Santa Cruz Downtown Plan Expansion

Draft Subsequent EIR Appendices

Appendix A

Notice of Preparation and Comment Letters

Figure 1: Project Location
Santa Cruz Downtown Plan Expansion Project
Draft Environmental Impact Report

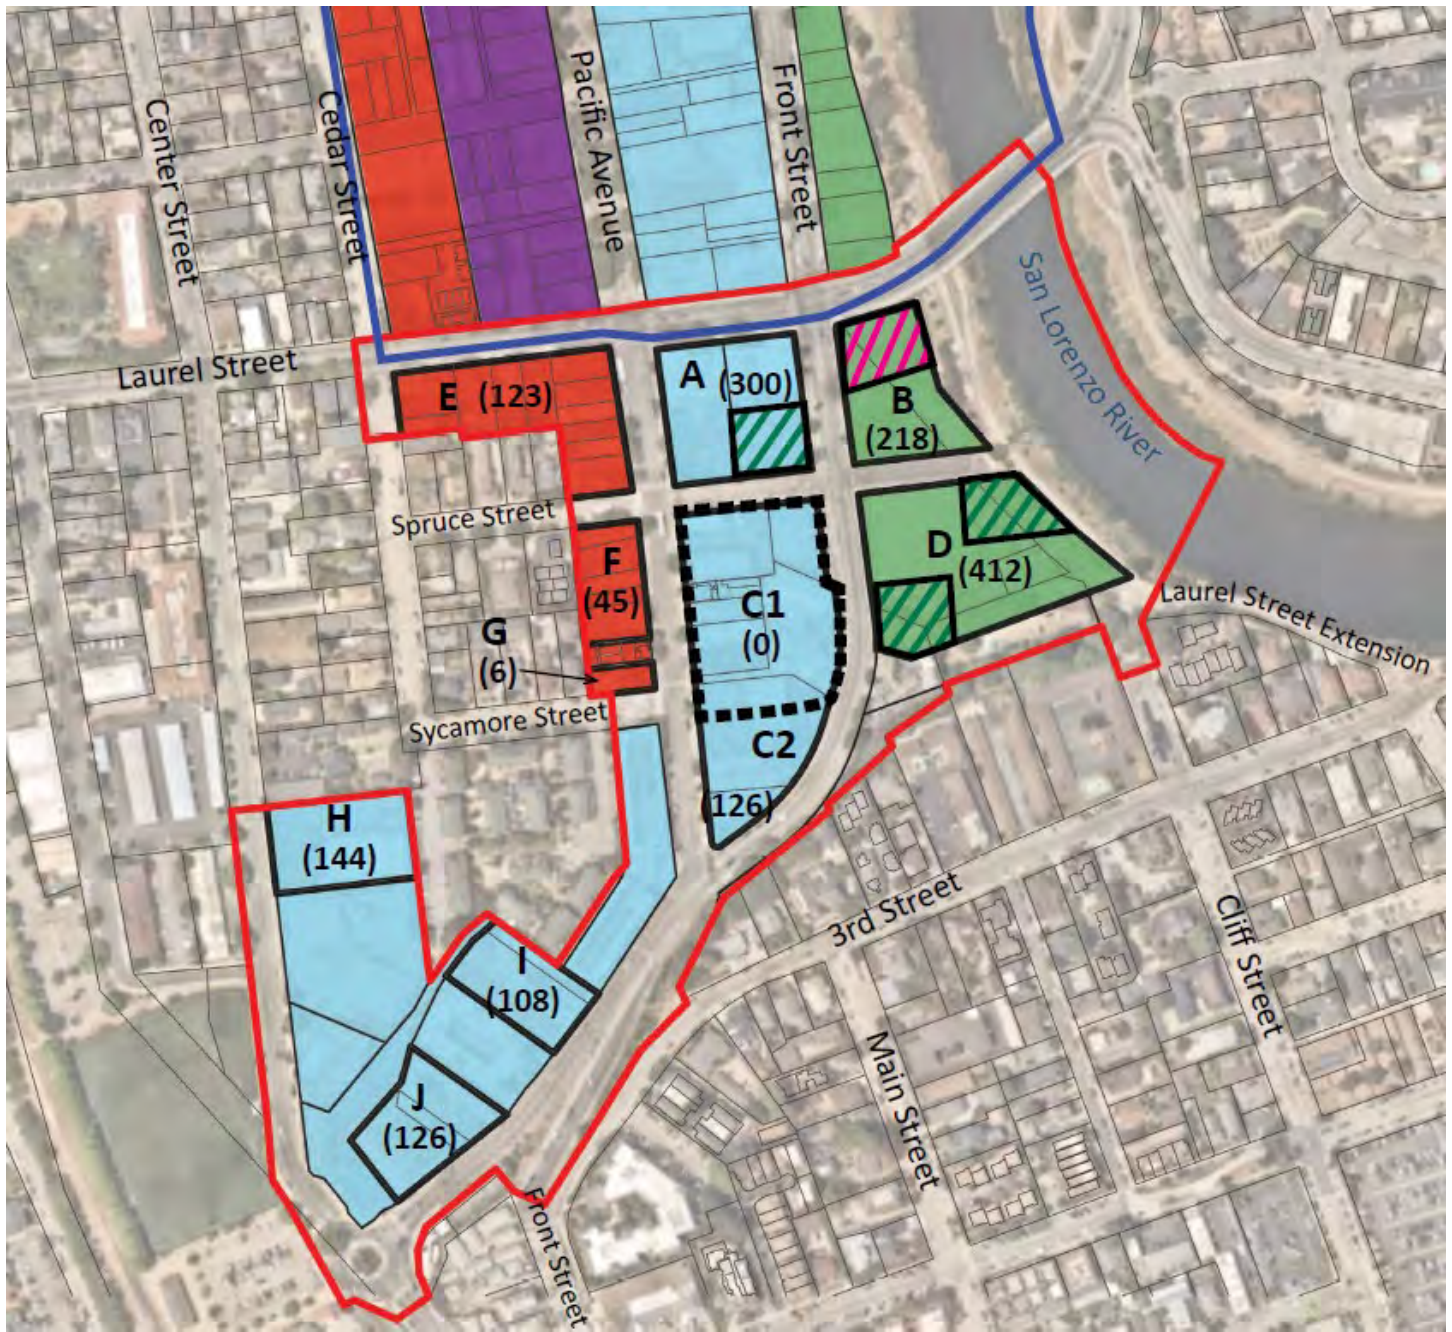
¹ The project area as shown in Figure 1 on page 6 of the NOP includes most, but not all of the Laurel Street Bridge and a portion of the San Lorenzo River itself. It is not clear from the NOP how the proposed project seeks to modify this area; however, it should be noted that depending on the scope and location of development ultimately proposed in this area, some portion of a project may fall within Commission's retained jurisdiction, and thus would be subject to a CDP issued by the Commission with the Coastal Act as the standard of review and the LCP as supplemental guidance.

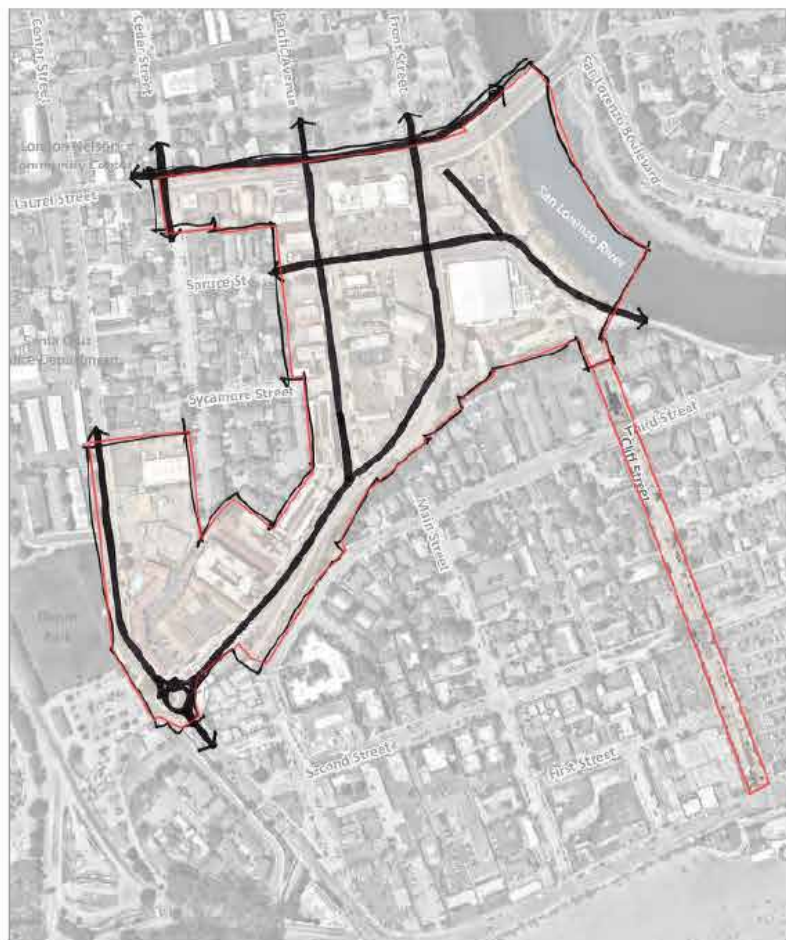
² Figure 2 on page 7 of the NOP indicates buildings heights of “75, 85 feet” for this area. The DSEIR should clarify whether the intention is to allow a range of heights between 75-85 feet depending upon whether certain criteria are met, if the intention is to allow maximum of 75 or 85 feet depending on the CEQA review process, etc.
